SLIDE-OUTS

Purpose

This document is for identifying the differences between the standard (Fig. 1) and inverted (Fig. 2) gear racks of an In-wall Slide-out system.

Fig. 1

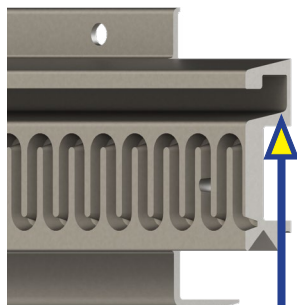
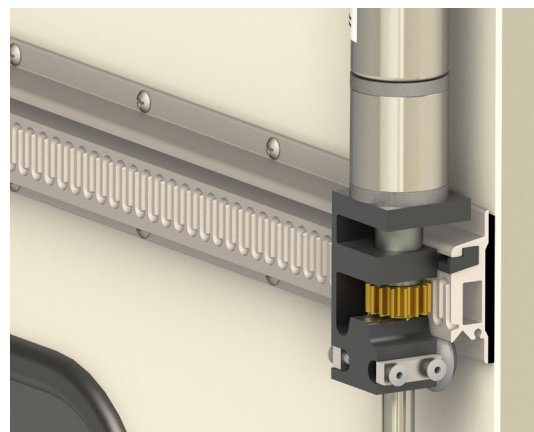
Starting March 2019, all In-wall systems were manufactured with the inverted gear rack system. There are specific repair kits available for the Standard and Inverted gear rack systems.

Inverted design allows for better water deflection.

If an entire standard system needs to be changed out, it will be replaced by an inverted system, but repair kits for the standard system will still be available.
